Attached please find a report entitled "Technical Analysis of the 2007 Dallas-Fort Worth 8-Hour Ozone SIP," which provides an independent review of the Dallas-Fort Worth Eight Hour Ozone Nonattainment Area Attainment Demonstration and the associated Chapter 117 rules, adopted by the Texas Commission on Environmental Quality on May 23, 2007, and submitted by the State of Texas to EPA on June 15, 2007.

Technical Analysis of the 2007 Dallas-Fort Worth 8-Hour Ozone SIP

**Submitted to:
The Honorable Richard Greene
Regional Administrator
Region VI
Environmental Protection Agency**

**Author:
Al Armendariz, Ph.D.
Department of Environmental and Civil Engineering
Southern Methodist University
Dallas, Texas**

Figure 3b. Long-Term Trends in Eight Hour Ozone Design Values in the DFW Area

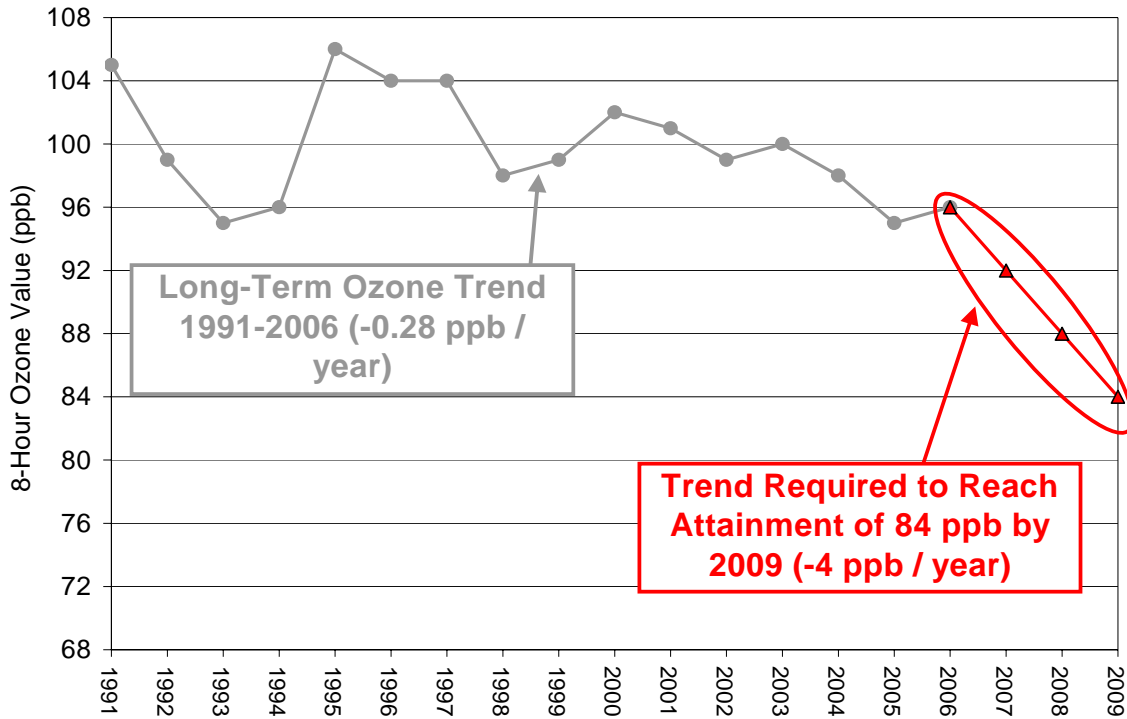
The weight of evidence from long-term ozone trends shows that it is highly improbable that the Submitted SIP will get the DFW area into attainment with the ozone standard by the attainment date. To do so, ozone concentrations would have to begin dropping immediately at a rate more than an order of magnitude greater than the long-term data show is actually occurring.

Unless EPA believes and can technically justify that ozone design values in the DFW area will begin dropping at the rate shown above in Figure 3b, the Submitted SIP must be found to be substantially inadequate, and must not be approved.

Figure 3-1: One-Hour and Eight-Hour Ozone Design Values in the DFW Area (1991-2006)

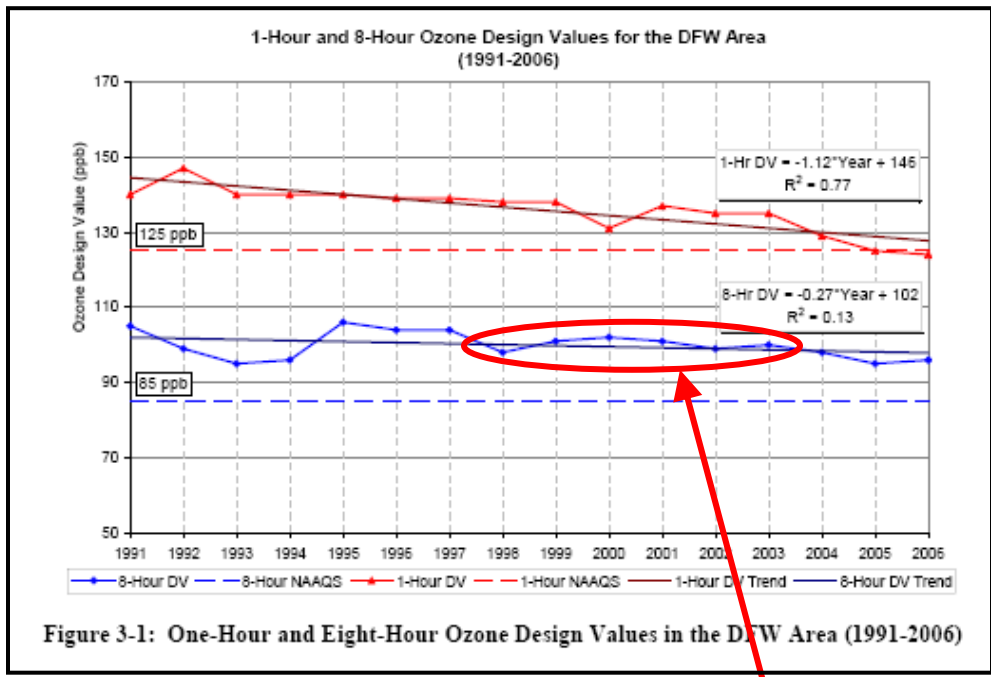
Figure 3-1 of the Submitted SIP shows that design values in DFW were virtually flat during the 1998 to 2003 time period, and actually increased slightly from 98 to 99 ppb. **The 21% reduction in known NOx emissions in DFW during this time period were completely insufficient to produce any reduction in measured ozone design values.**

1998 to 2003 NOx Reductions Insufficient to Reduce 8-Hour Ozone DVs

Given the lack of response in ozone design values to the NO_x emissions reductions from 1998 to 2003, it is important to compare the emissions reductions during this period to those planned in the Submitted SIP. From 1998 to 2003, DFW NO_x emissions were reduced 150 tpd or 21%. The Submitted SIP currently under review is based on NO_x reductions from 2006 to 2009 of approximately 60 tpd or 13% (from 480 tpd to 420 tpd).

Figure 3f. Trends Required for Attainment at the Denton Monitor

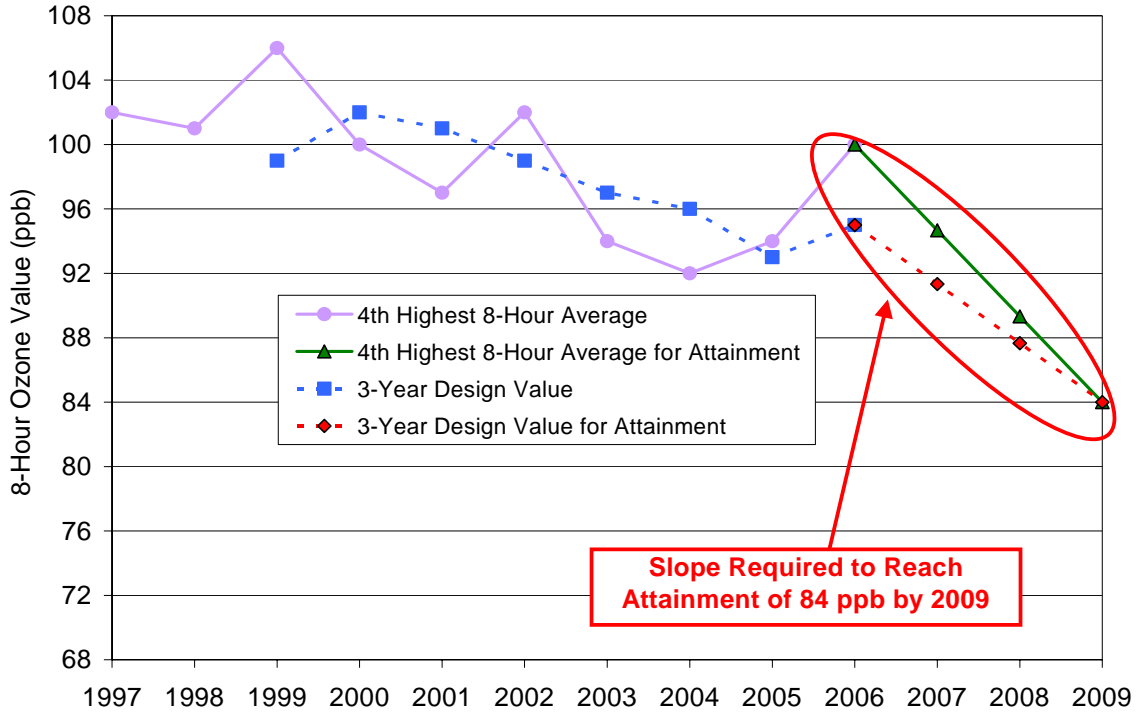
Figure 3f shows that the rates of reduction in ozone concentration at the Denton monitor would have to be at unprecedented levels for the monitor to show attainment with the ozone standard. Since the emissions reductions in the Submitted SIP are even smaller than emissions reductions in previous years that failed to provide large drops in ozone levels, the weight of evidence is compelling that the Denton monitor will continue to be in nonattainment and above 84 ppb on the attainment date.

Unless EPA believes and can technically justify that ozone design values at the Denton monitor will begin dropping at the rate shown above in Figure 3f, the Submitted SIP must be found to be substantially inadequate, and must not be approved.

Figure 3g. Trends Required for Attainment at the Eagle Mountain Lake Monitor

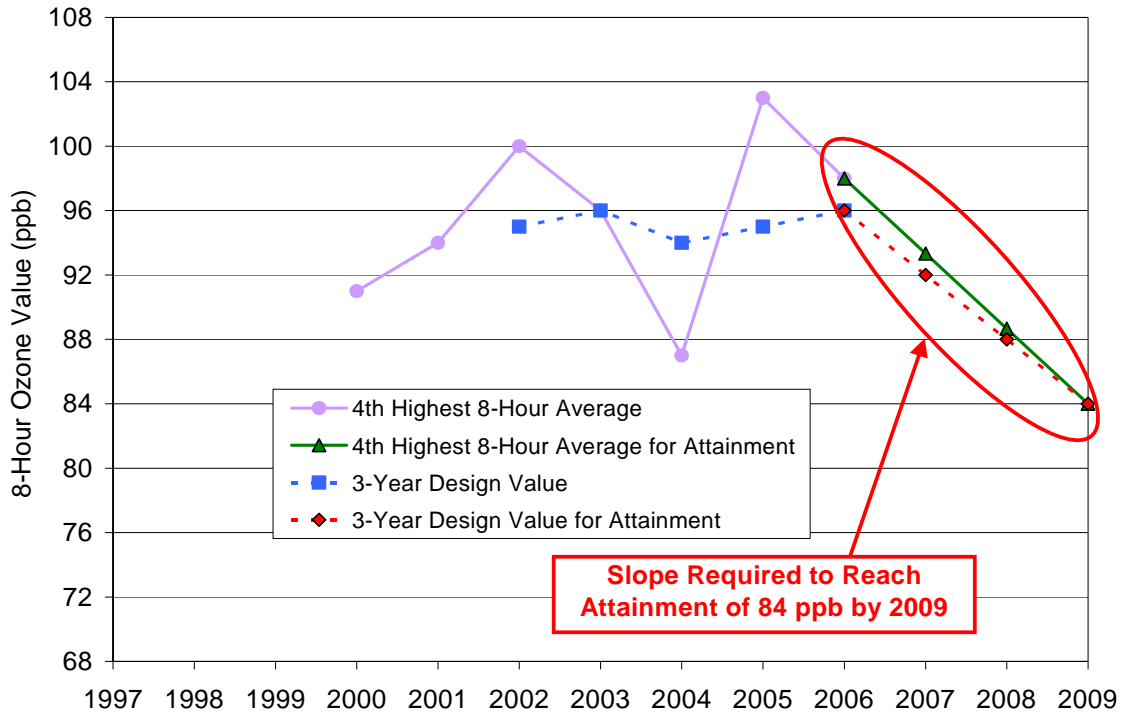
Figure 3g demonstrates that the rate of reduction in ozone concentration at the Eagle Mountain Lake monitor in Tarrant County would have to be at improbable levels for the monitor to show attainment with the ozone standard by 2009. The weight of evidence is strong that the Eagle Mountain Lake monitor will continue to be in nonattainment and above 84 ppb.

Unless EPA believes and can technically justify that ozone design values in at the Eagle Mountain Lake monitor will begin dropping at the rate shown above in Figure 3g, the Submitted SIP must be found to be substantially inadequate, and must not be approved.

Figure 5a. Benefit of 90% NO_x Control on the Ellis County Cement Plants.
(ENVIRON 2005, Figure 2, p. 5)

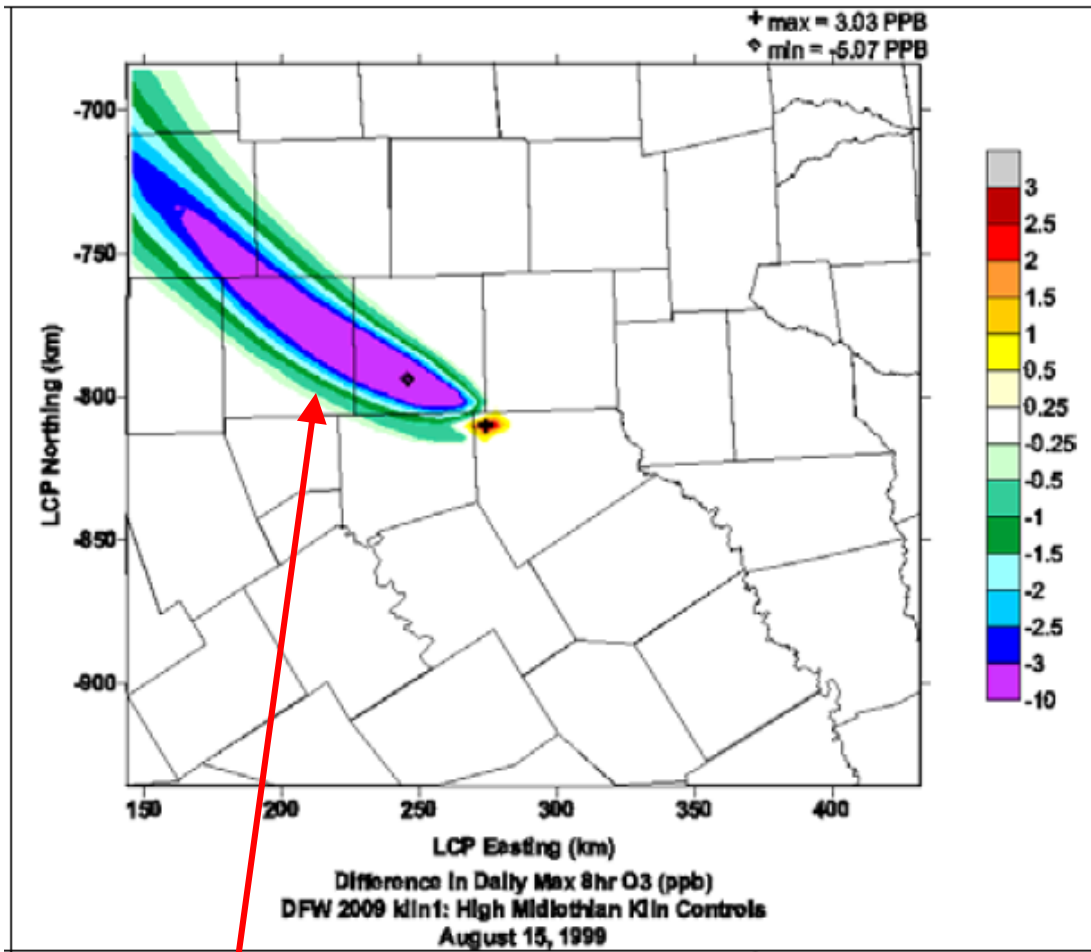
Ozone reduced 1 to 5 ppb across much of Tarrant, Parker, and Wise Counties by advanced NO_x controls on the cement kilns on Day 1 of ENVIRON study.

Figure 5b. Benefits of 90% NO_x Reductions from the Ellis County Cement Plants.
(ENVIRON 2005, Figure 2, p. 5)

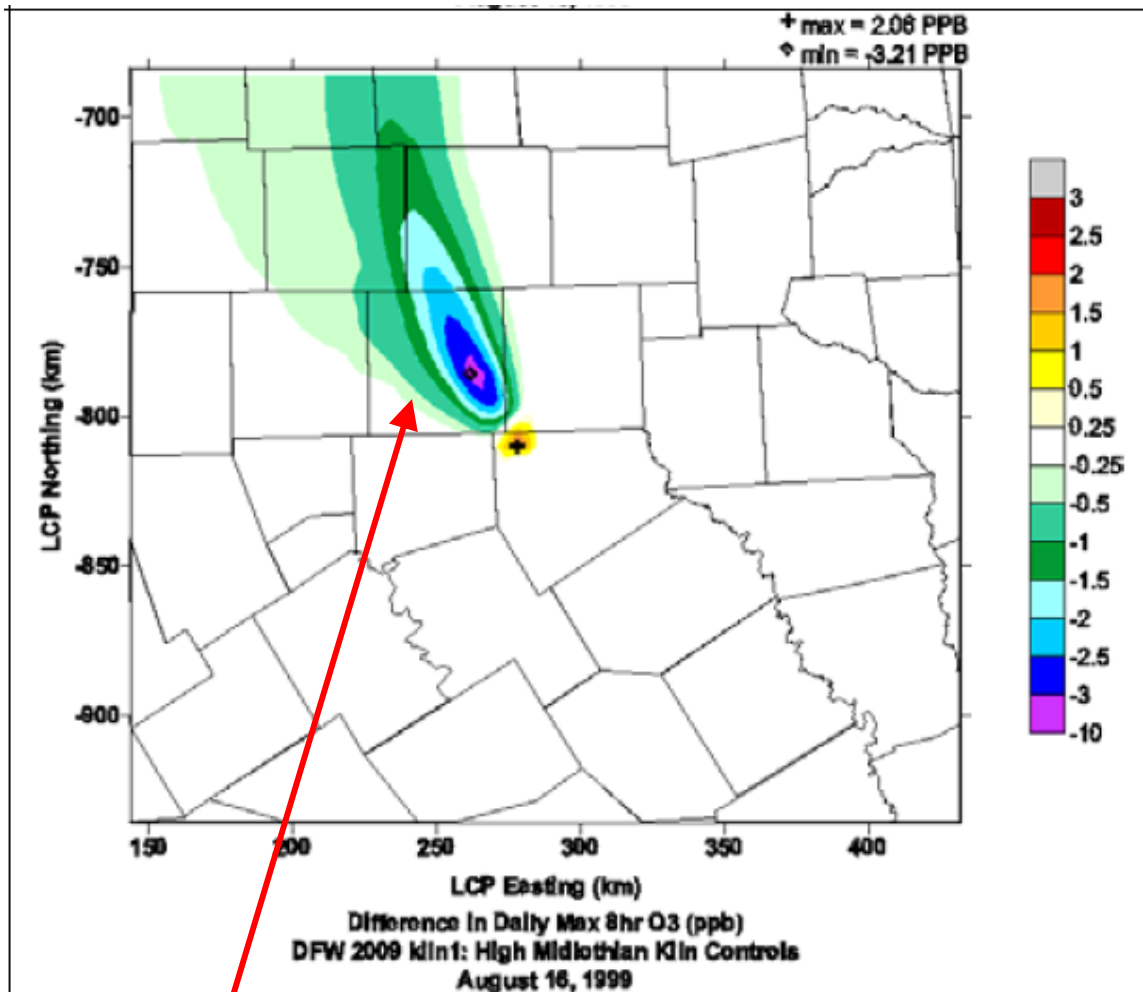
Ozone reduced 1 to 3 ppb across much of Tarrant and Denton Counties by advanced NO_x controls on the cement kilns on Day 2 of ENVIRON study.
